Mazda 3 - Cooling capacity diminishes while driving | HELLA

Mazda 3

Cooling capacity diminishes while driving

Figure 1

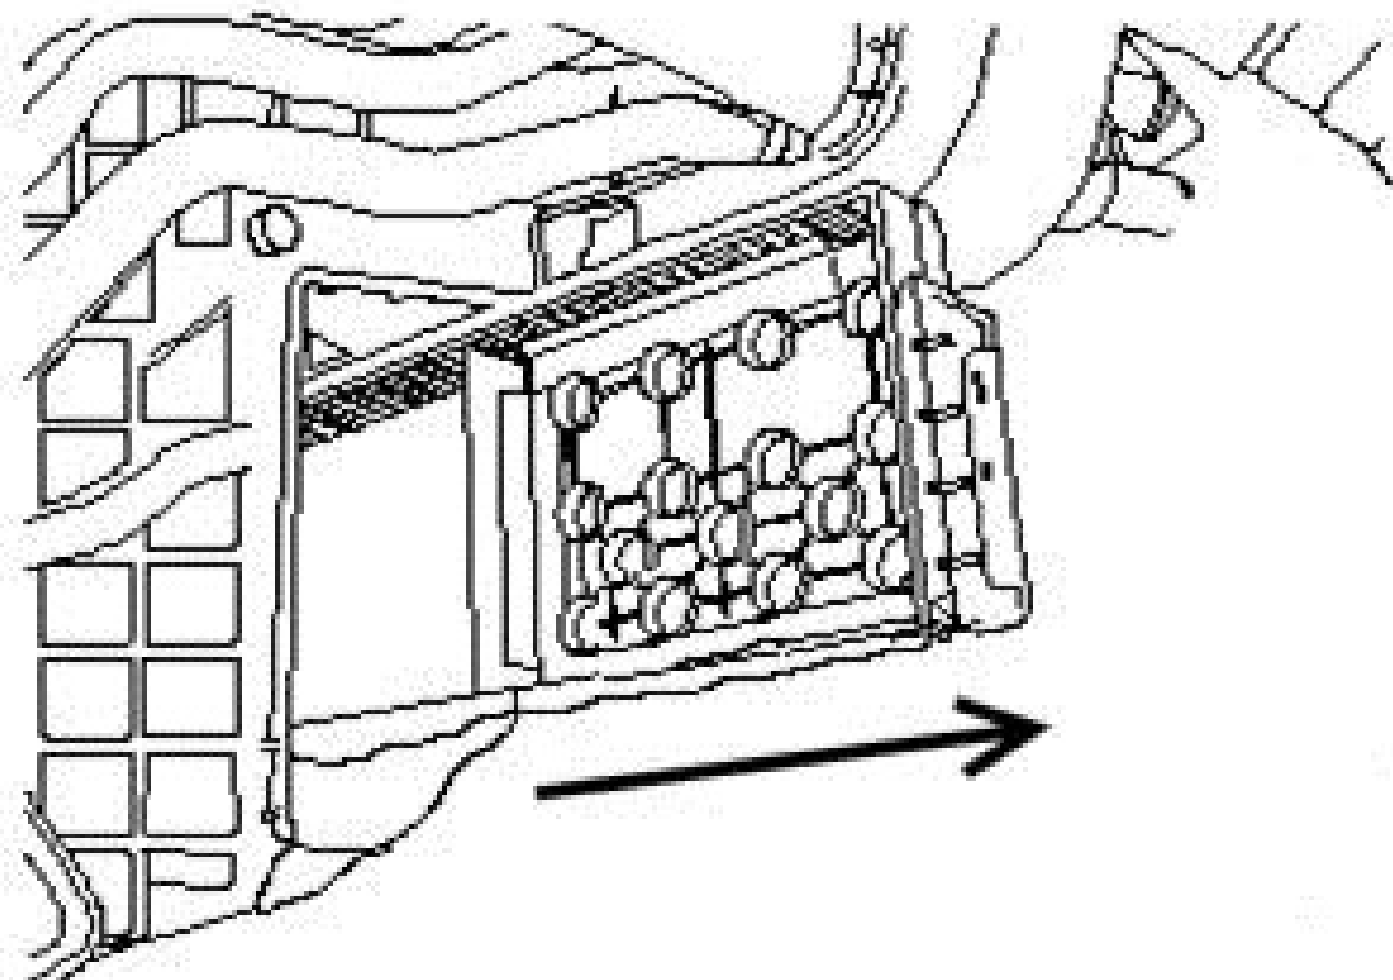
In the course of a longer journey made in one of the above-mentioned vehicles (with the air-conditioning running at full speed), it is possible that the cooling capacity of the air-conditioning system begins to diminish. A reason for this can be the freezing of the evaporator.

Possible causes of this trouble are faulty temperature sensors on the evaporator and also an uneven distribution of air flowing through the evaporator.

- Now take out the upper and lower filters of the air-conditioning system
- Insert the new filters with the diffusion plate (Fig. 1) and make sure that the arrows on the filter are pointing in the direction of the rear (Fig. 2). Replace the cover on the evaporator box
- Connect the short wiring harness including resistance with the plug. Then connect both with the temperature sensor on the evaporator

This problem can be solved by renewing a sensor that has to be correctly adjusted (including its resistance) and by replacing the interior filter to achieve improved air distribution.

- BP8P-61-J6X Filter set with diffusion plate

- BPY-61545A Wiring harness with resistance
